SUMMARY OF CHANGES TO ITS CHAPTER 4.0

SUMMARY OF CHANGES TO ITS SECTION 4.0 - REVISION D

**JAFNPP
IMPROVED TECHNICAL
SPECIFICATION (ITS)
CONVERSION PACKAGE**

Section 4.0 - DESIGN FEATURES

FIGURE 3.1-1. IES and Exclusion Area
SITE BOUNDARY/HAD
(4)
(AI)
(AL)
(LAI)

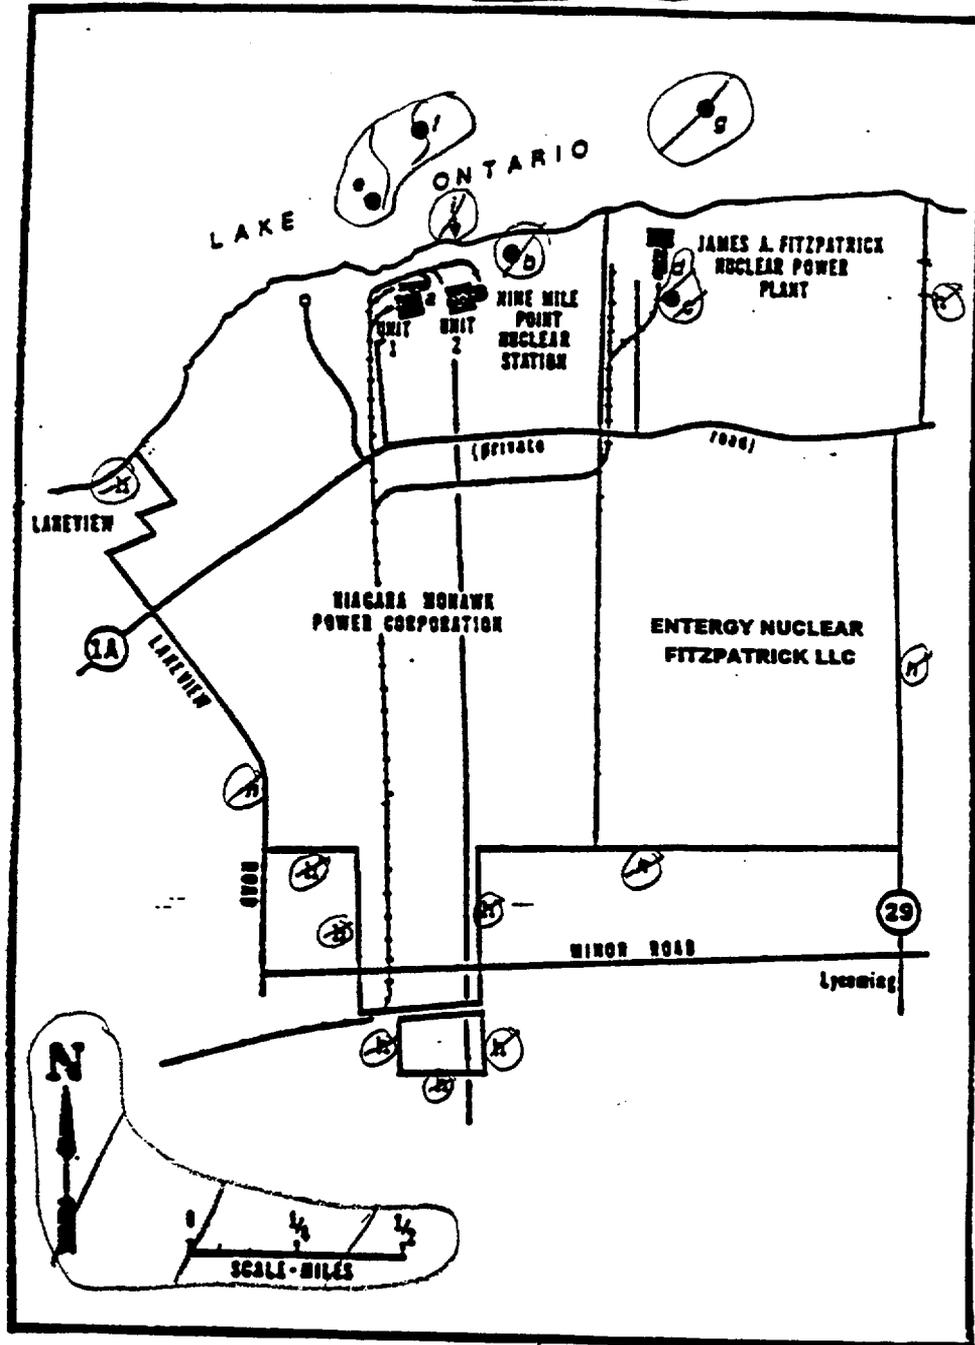
- LA1 Details of the Site features in CTS RETS 1.0.L, CTS 5.1.1, CTS 5.1.2, and Figure 5.1-1, the details of the Reactor Pressure Vessel described in CTS 5.3, the details of the Containment described in CTS 5.4 and the details of the Seismic Design in CTS 5.6 are proposed to be relocated to the UFSAR. The Site Features remain described in UFSAR Section 2.1.1. Design parameters of the Reactor Vessel and Containment remain detailed

FIGURE 4.1-1 (PAGE 1 OF 1)
SITE AND EXCLUSION AREA BOUNDARIES

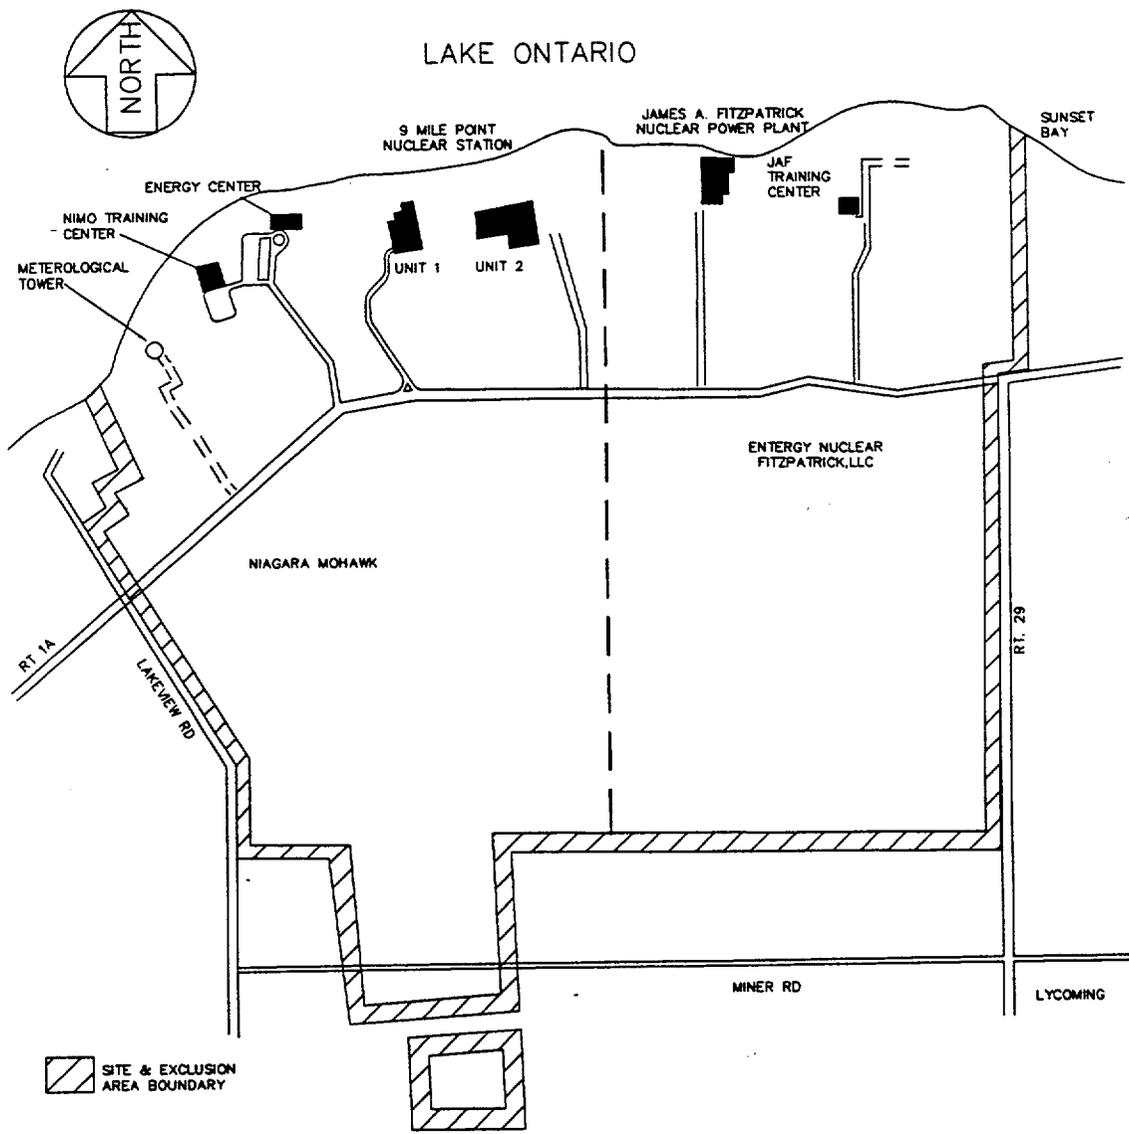
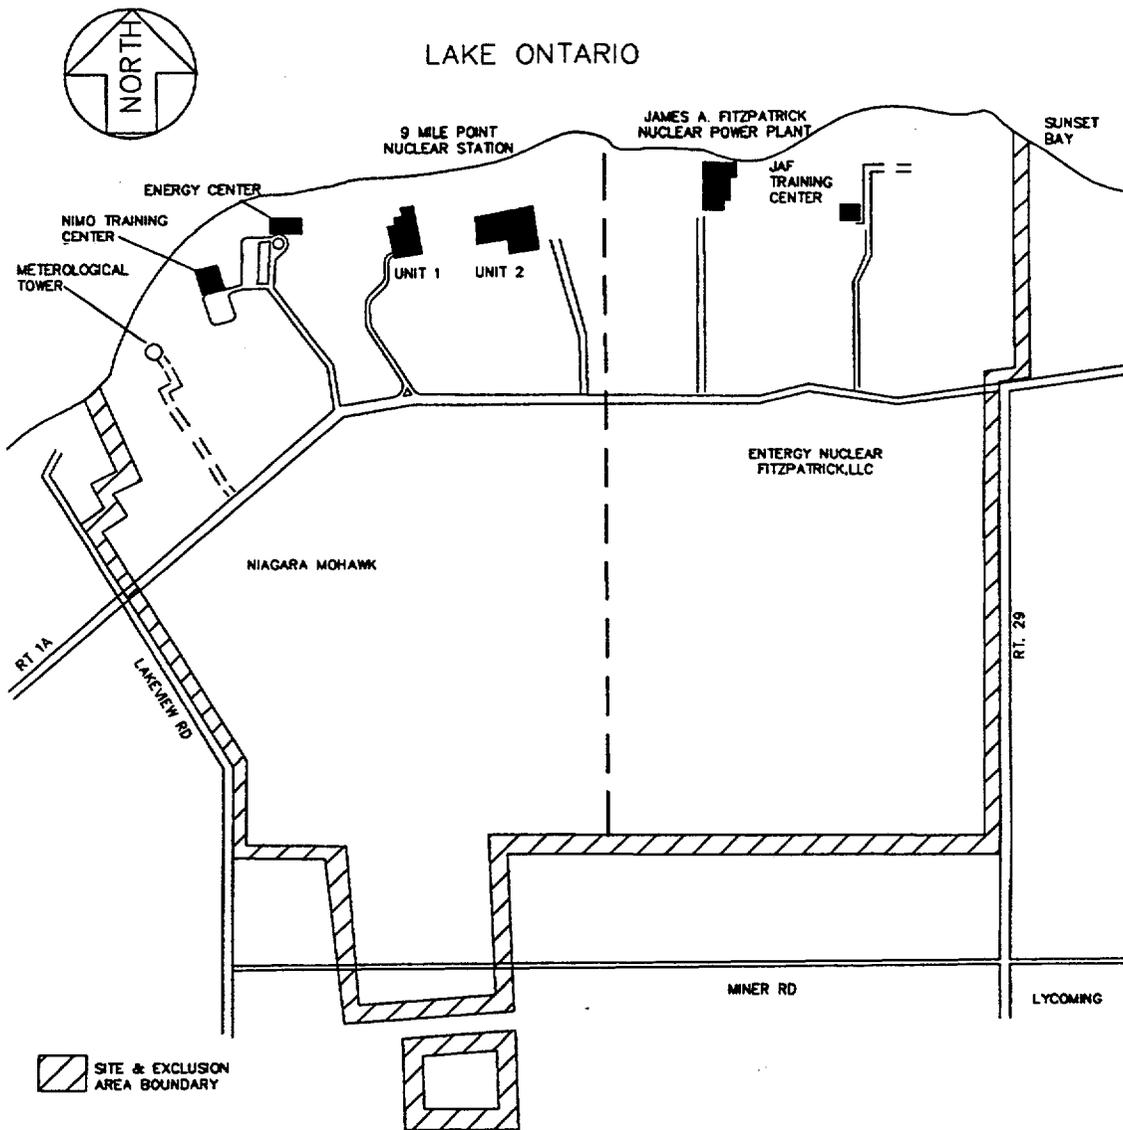
Oversight Correction	ITS Figure 4.1-1 is redrafted to include the portion of the Site Boundary beyond the railroad right-of-way south of Miner Road. This revision to the ITS Figure makes the figure consistent with the corresponding CTS Figure 5.1-1 and consistent with Emergency Plan Figure 2.5.	ITS mark-up p insert 4.0-2 Retyped ITS p 4.0-4
License Amendment 256	Amendment 256 revised the Technical Specifications to reflect the addition of racks increasing spent fuel pool storage capacity from 2797 to 3239 fuel bundles, with additional changes to assure the fuel in the pool remains in a subcritical condition. Revision D ITS changes reflect the issuance of Amendment 256 and correct an error in the original ITS submittal which incorrectly identified spent fuel pool capacity as "3247 fuel assemblies".	CTS mark-up pp 2, 4 of 7
License Amendment 268	Amendment 268 reflects the change in ownership of JAF from NYPA to Entergy. The CTS mark-up and ITS Figure 4.1-1 are revised to reflect issuance of this amendment.	CTS mark-up pp 1, 2, 6 of 7 ITS mark-up p insert 4.0-2 Retyped ITS p 4.0-4
